Subject: Suwannee American Cement Company
Response to Requests for Additional Information
DEP File No. 1210465-001-AC (PSD-FL-259)

ADDITIONAL INFORMATION

**IN SUPPORT OF
AN APPLICATION FOR A PSD
CONSTRUCTION PERMIT
REVIEW**

**DEP File No. 1210465-001-AC
PSD-FL-259**

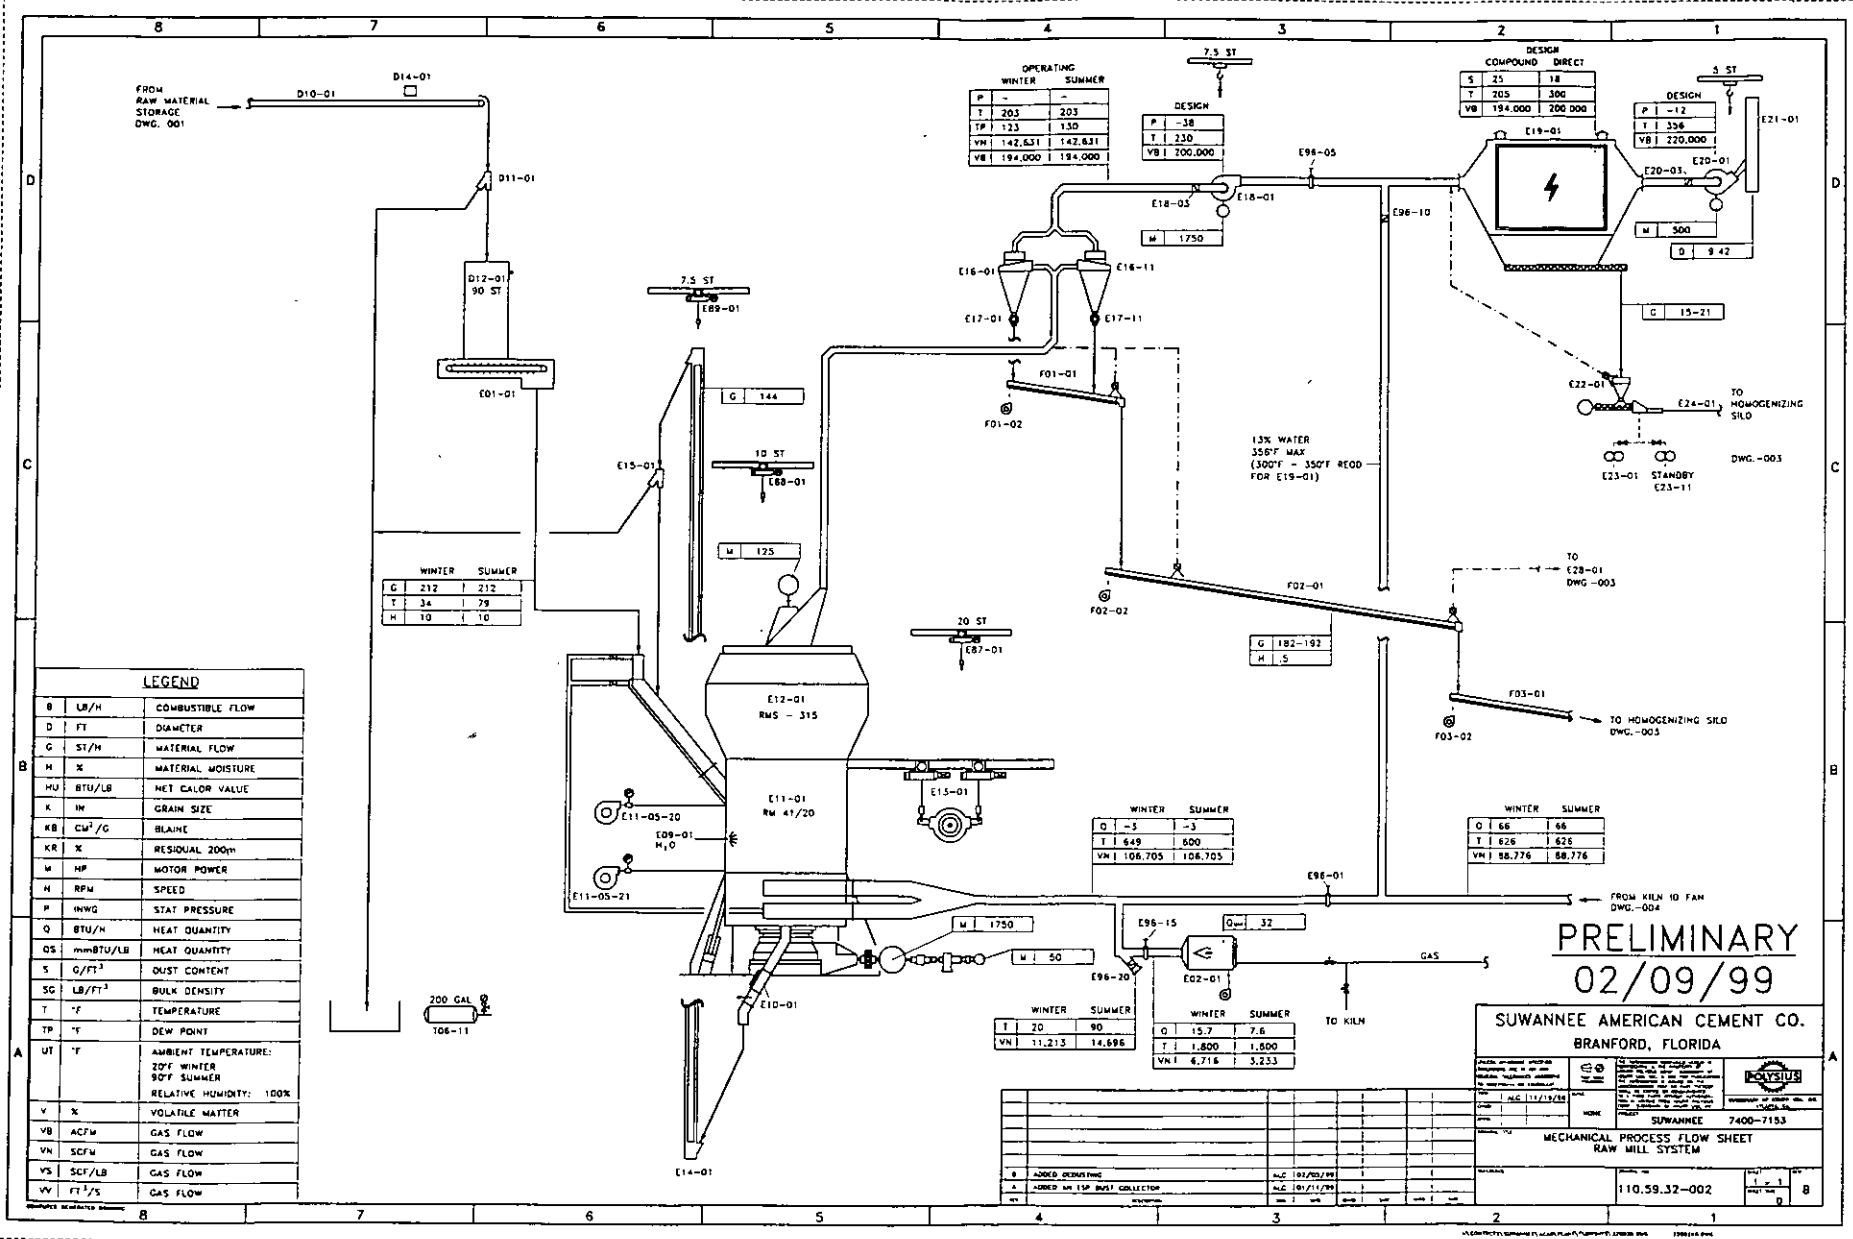
1. Please finalize the design of the precalciner and submit revised drawings that do not show this process as "on hold". Provide a description of the final process design selected. We understand the applicant is considering utilizing a tire gasification system to fuel the precalciner burner. If this option has been selected, please provide a process description of the gasification system, describe how the solid byproducts of the gasification system will be utilized in the cement process, and discuss the impact of the gasification system on emissions.

The cyclone preheater with the MSC Precalciner, the rotary kiln and the grate-type clinker cooler comprises Polysius most efficient pyroprocessing system for both heat and electrical energy consumption as the system maximizes heat transfer and minimizes fuel requirements. This results in a low specific exhaust gas volume. With this system, 50-60 percent of the total system fuel is fired at the precalciner and 40-50 percent is fired at the main kiln burner. The 50-60 percent of the fuel fired at the precalciner is split with approximately 10 percent (of total system fuel) being fired at the kiln inlet burner (at the point where the feed enters the kiln) and the remaining 40-50 percent of the total system fuel fired in the Combustion Chamber (CC).

This system was selected for Suwannee American Cement not only because it represents the state-of-the-art in pyroprocessing system technology but also because it provides the most effective means of nitrogen oxides (NOx) reduction available. By minimizing the amount of fuel fired at the main kiln burner (40-50 percent of the total system fuel), the

high temperature and high thermal NOx producing combustion necessary for clinkering and maintaining the quality of product is minimized. The fuel fired at the precalciner is burned in a lower temperature reducing zone where very little thermal or fuel NOx is generated. Furthermore, the reducing atmosphere functions to reduce the thermal NOx that was previously produced in the kiln. The combined features make the precalciner kiln with MSC the most efficient pyroprocessing system available from the standpoint of fuel efficiency, low specific exhaust volumes and inherent NOx emission control.

Integration of the gasifier into an AS-plant

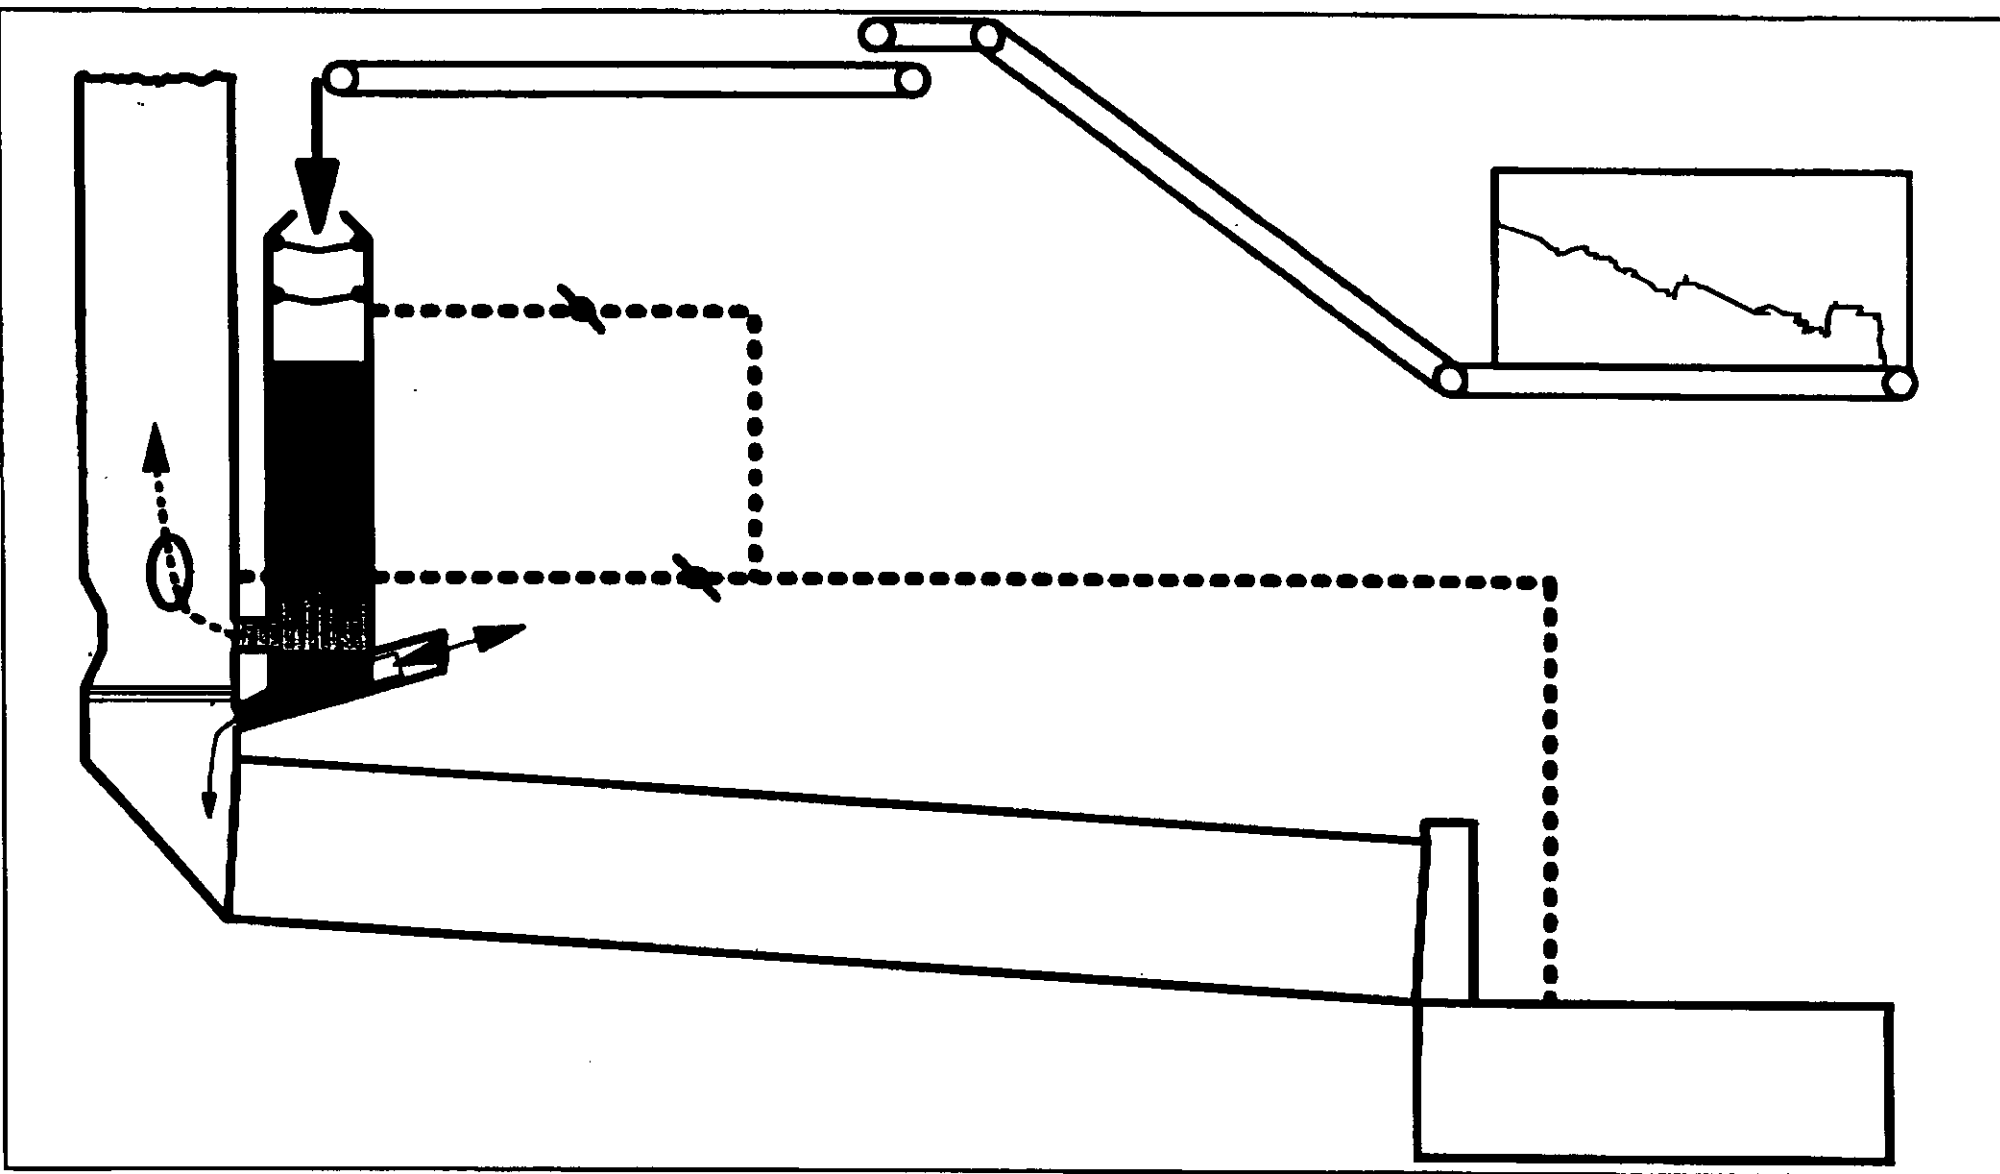
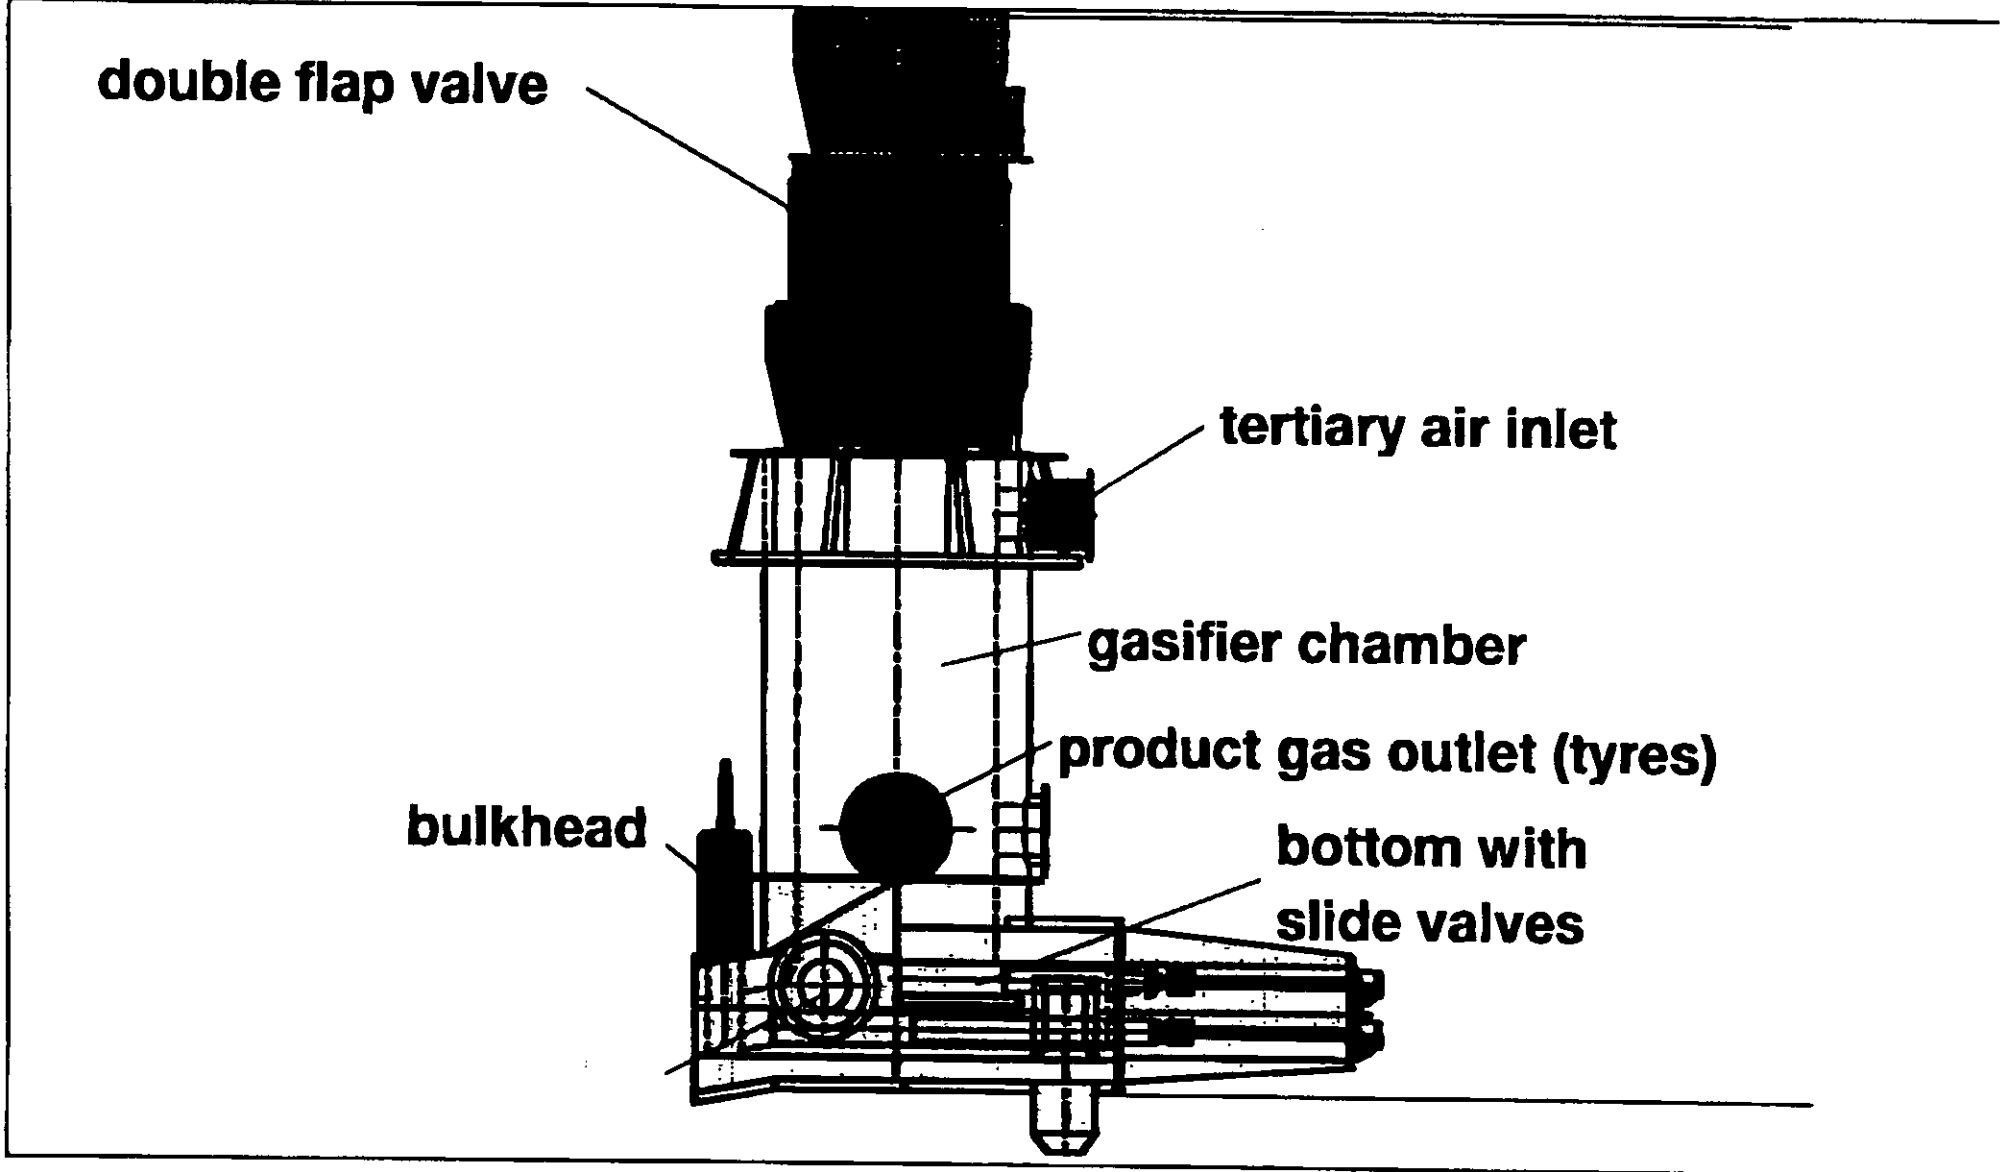
2. The application proposes the use of tires to provide up to 40% of the heat input to the pyroprocessing system. Representatives from Krupp Polysius stated that firing no more than 10% tires is practically achievable without the use of a tire gasification system. Further, the proposed volume of tires may result in no fuel being fed to the precalciner which would provide no supplemental heat in the flue gas downstream of the kiln end feed shelf (which we presume will be the introduction point for tires). Operation of this sort seems to violate the principles of NOx control by process design described on page 49 of the supplemental report, in which more fuel is fired in the precalciner than the kiln. Please propose a volume of amount of tires that comports with the recommendation of the pyroprocessing system's manufacturer, or provide more information to support the requested feed rate. Please verify the location of the feed point for tires or TDF.

The request in the permit application to use TDF to provide up to 40 percent of the total system heat input was based on the possible use as a tire gasifier.

Without the gasifier, approximately 10-15 percent of the total system fuel can be supplied by TDF. The substituted fuel could be seen as a replacement for fossil fuel that would normally be fired at the kiln inlet burner. For permitting purposes, Suwannee American is requesting that up to 15 percent of the total system heat input be supplied by TDF if the gasifier is not used, and up to 45% of the total system heat input be supplied by TDF if the gasifier is used. The details of the gasifier are described further in the response to Item 1.

When the gasifier is used, the TDF is fed into the gasifier in batches. The gasifier itself is quite simple. Whole tires are fed via an airlock mechanism to a cylindrical reactor. A small portion of the tertiary air (temperature = 750 - 900° C) is injected into the reactor to serve as the gasifying agent. At a excess air factor of 0.2 to 0.4, the tires are decomposed to gas, residual coke and wire. The gas, laden with hydrocarbons and free radicals, is injected into the calciner as fuel to replace the coke or coal. The residual coke and wire is pushed from the bottom of the reactor into the kiln inlet housing at roughly the same place where conventional tire feeding systems introduce the whole tires. The gas is burned in calciner in a staged combustion approach and the residual coke burns out in the entrance to the kiln. The wire melts and is incorporated into the clinker.

MECHANICAL PROCESS FLOW SHEET
RAW MILL SYSTEM

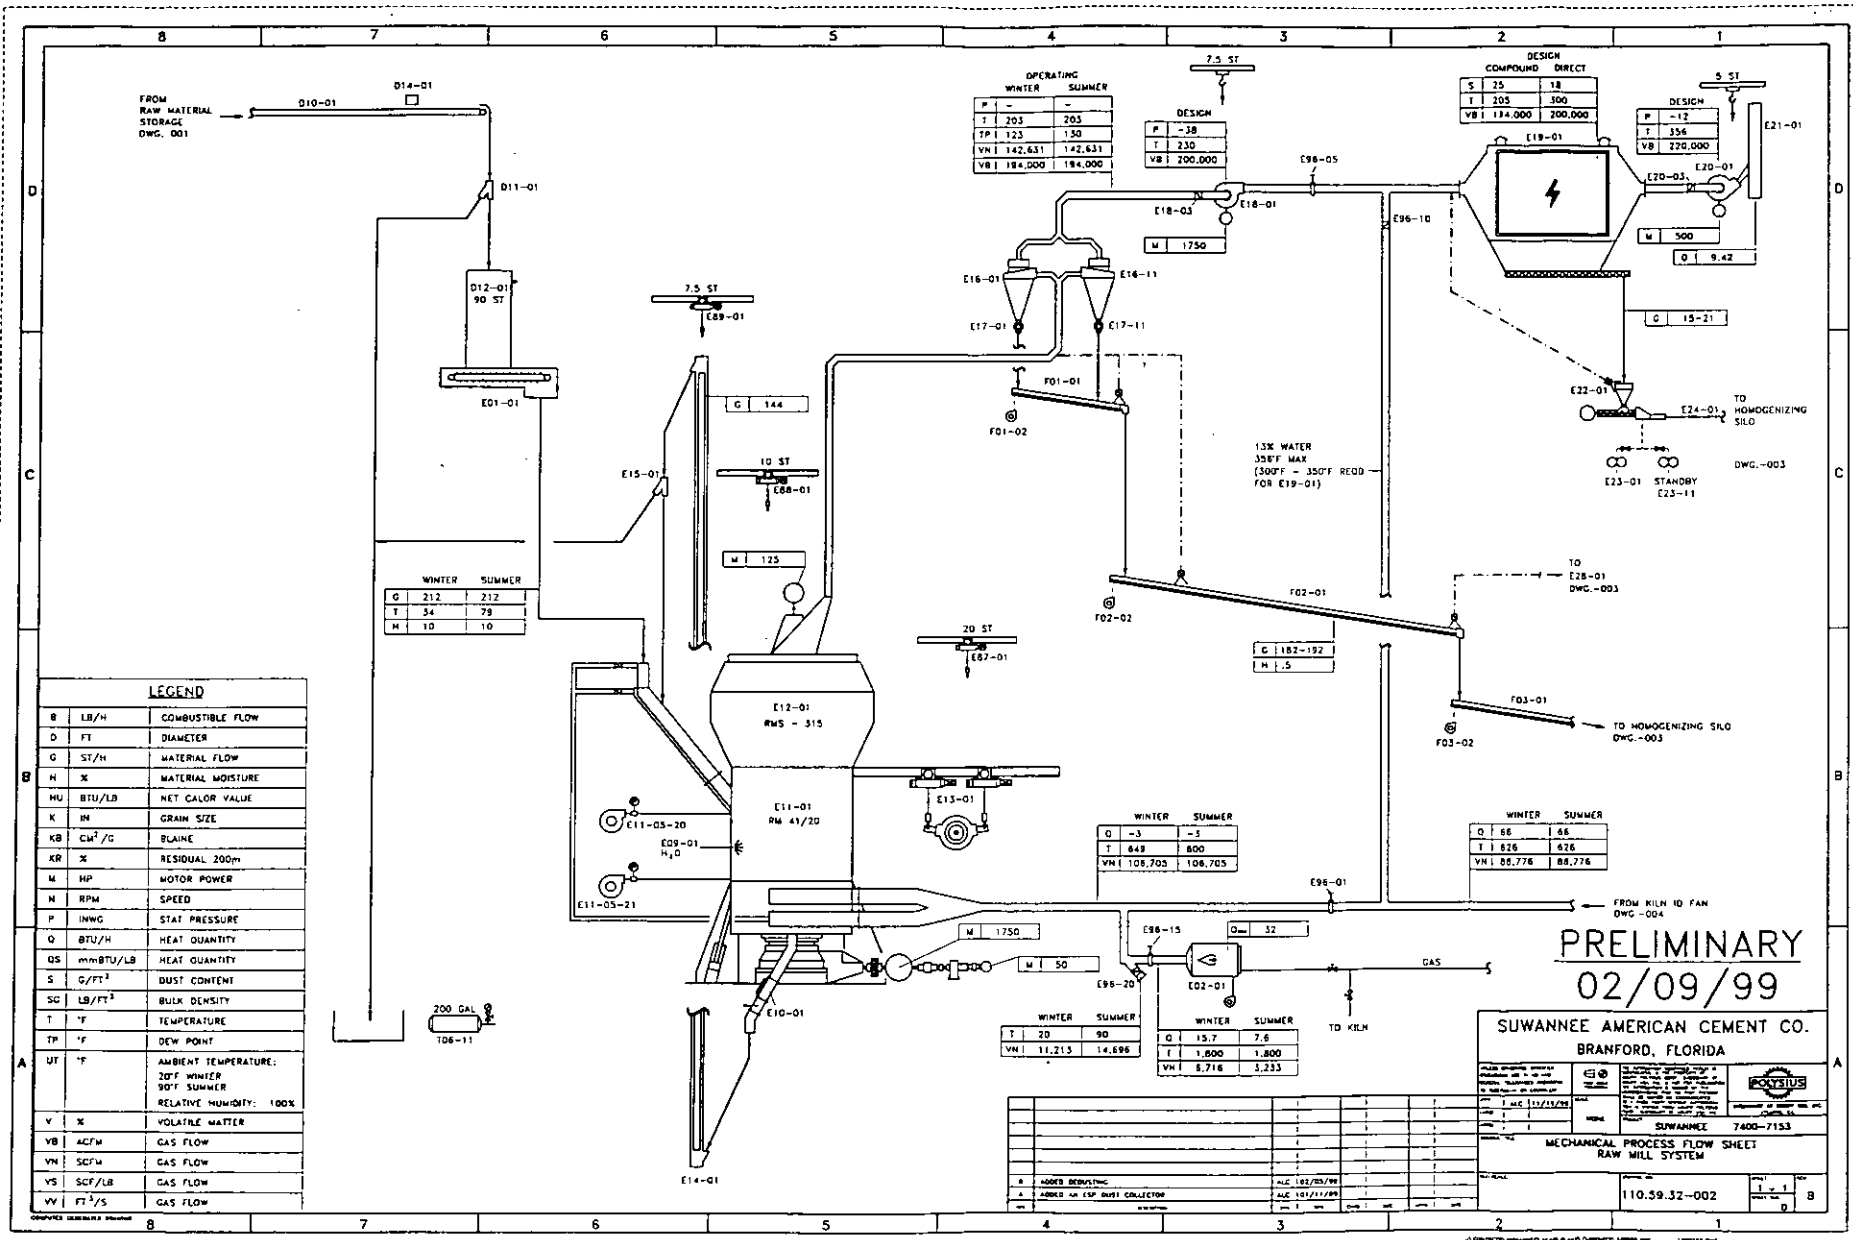
- 7
3. Please finalize the design of the particulate control devices for the in line kiln/raw mill and the clinker cooler and submit revised drawings that do not show the control device for the clinker cooler as "under review". Provide a description of the final control devices selected, and specifications for each device.

Particulate matter emissions from both the kiln/raw mill system and the clinker cooler will be controlled by electrostatic precipitators. Identical precipitators will be used at the two locations. The description and technical specifications of a precipitator sized for this specific application by Environmental Elements Corporation is with this response. This precipitator or an equivalent precipitator will be selected by Suwannee American.
